SUBJECT: McGUIRE NUCLEAR STATION, UNITS 1 AND 2 - ISSUANCE OF AMENDMENTS RE: (TAC NOS. MA5994 AND MA5995)

The amendments revise the minimum reactor coolant system (RCS) flow rate limit, reduce the reactor coolant average temperature and pressurizer pressure limits, restrict operation to a RCS flow deficit of no more than one percent, and change the low RCS flow reactor trip setpoint.

ATTACHMENT TO LICENSE AMENDMENT NO. 191

Replace the following pages of the Appendix A Technical Specifications and Bases pages with the attached revised pages. The revised pages are identified by amendment number and contain marginal lines indicating the areas of change.

Figure 2.1.1-1

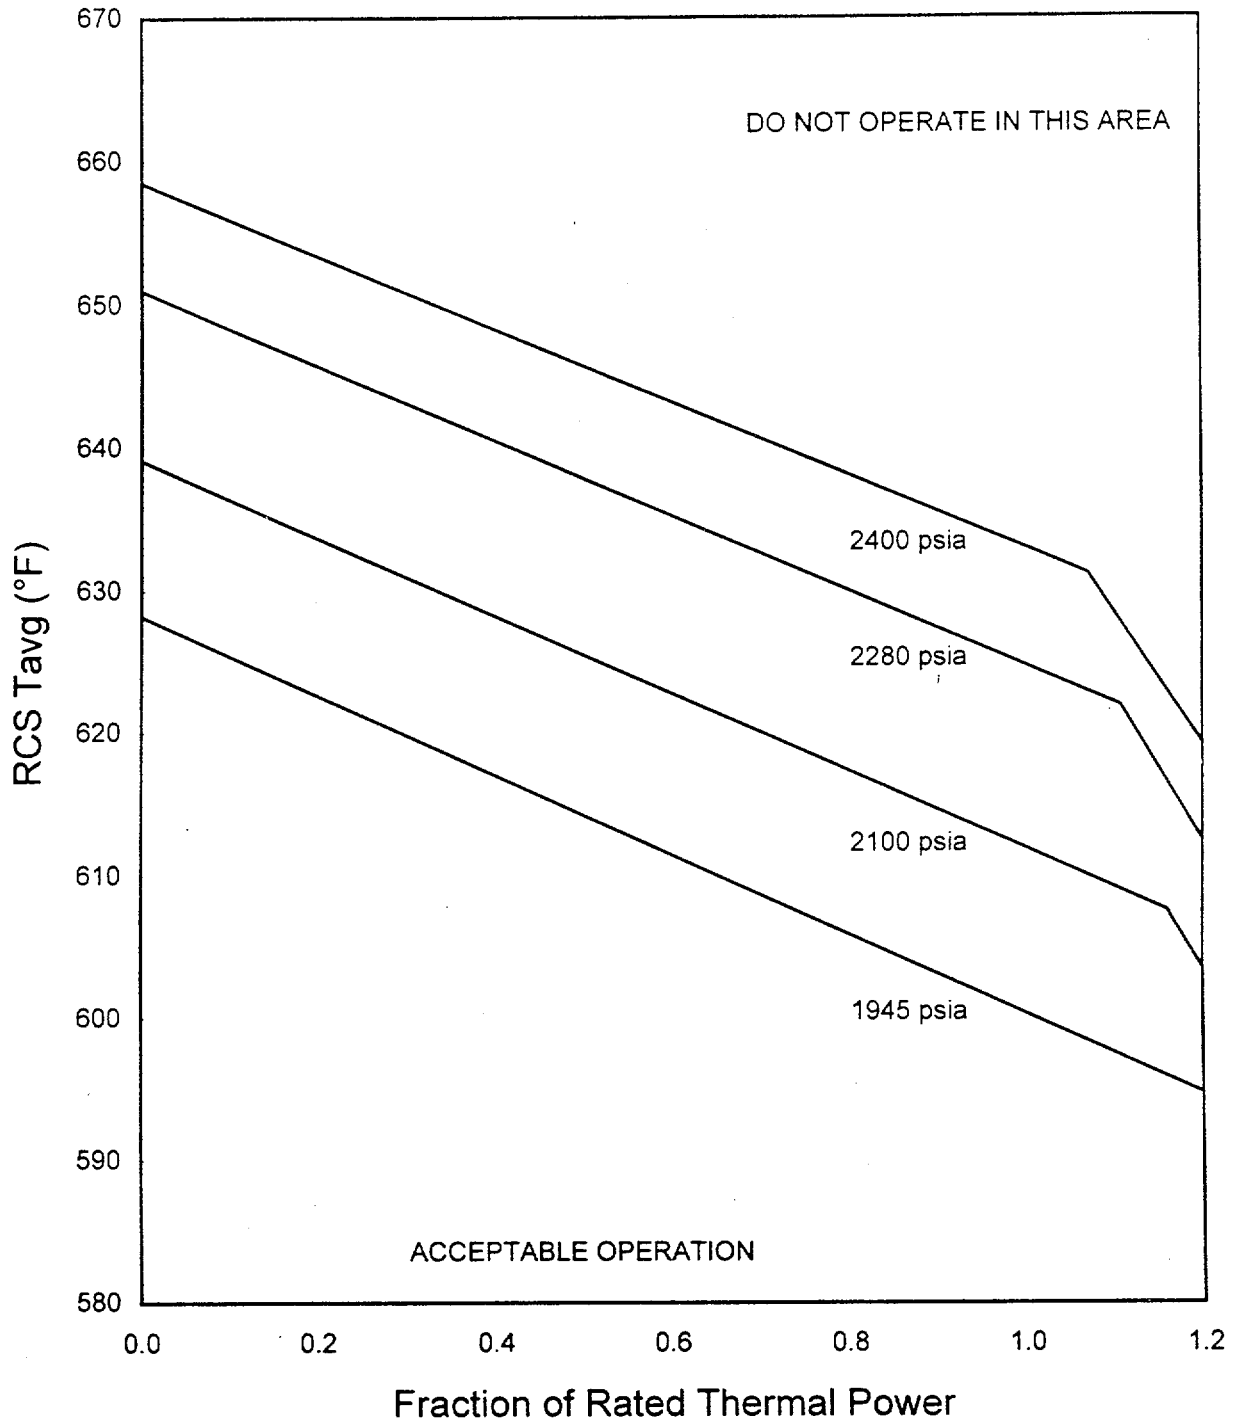
The Safety Limit curves in Figure 2.1.1-1 will be revised due to the proposed change in minimum RCS total flow rate limit to 390,000 gpm.

The safety limit curves in TS Figure 2.1.1-1, "Reactor Core Safety Limits - Four Loops in Operation," are revised. The safety limit curves show the loci of points of thermal power, reactor coolant system pressure and average temperature below which (1) the calculated DNBR is not less than the design DNBR limit or (2) the average enthalpy at the vessel exit is less than or equal to the enthalpy of the saturated liquid. These curves are revised slightly higher as a result of the increase in the RCS flow limit to 390,000 gpm. The safety limits do not affect the normal operation of the facility, but are only used to determine the need for further safety evaluations following postulated overheating or power excursion transients. Since the axial flux difference limits of LCO 3.2.3 are unchanged, all the current thermal hydraulic design criteria continue to be satisfied. The licensee has determined that the constants in the overtemperature ΔT (OT ΔT) and overpower ΔT (OP ΔT) setpoint equations are conservative and provide the necessary reactor protection. These OT ΔT and OP ΔT reactor trips are assumed in the Chapter 15 analyses.
